To: Bill Huffman - NRC
Subject: NRC/W NOTRUMP Meeting
Date: March 5, 1997
Pages: 13, including this cover sheet.

Attached is a partially complete table on the "road-map" to close OIS/RAIs/etc. for NOTRUMP V&V related issues. Please give Ralph Landry a copy so he can have a chance to review before we meet. We'll discuss this as part of Thursday meeting. Thanks.

471.23-3
Rev. 1

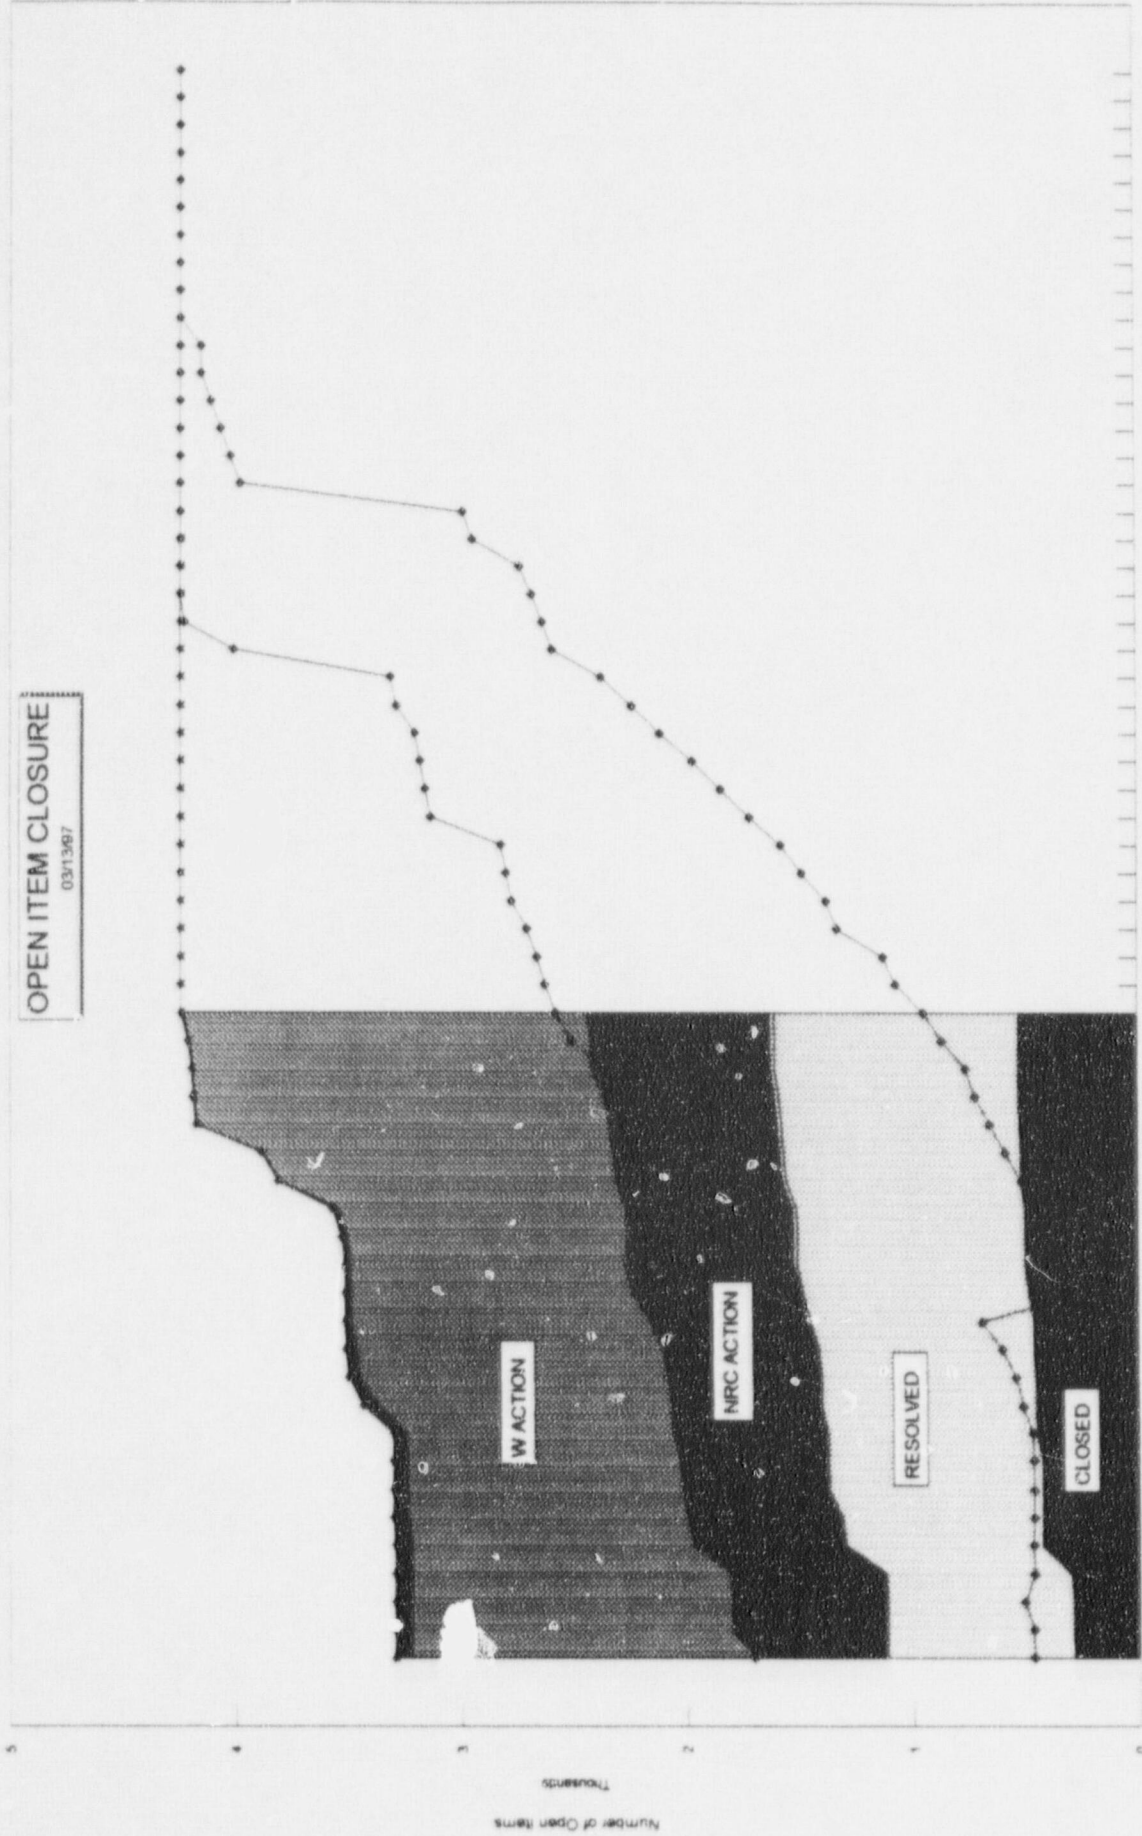
Verify that the airborne radiation monitors described in Section 11.5.2.3.2 of Chapter 11 of the SSAR will be sensitive enough to detect 10 DAC-hrs in any area of the plant that can be accessed by plant personnel.

- In "Notes:" add:
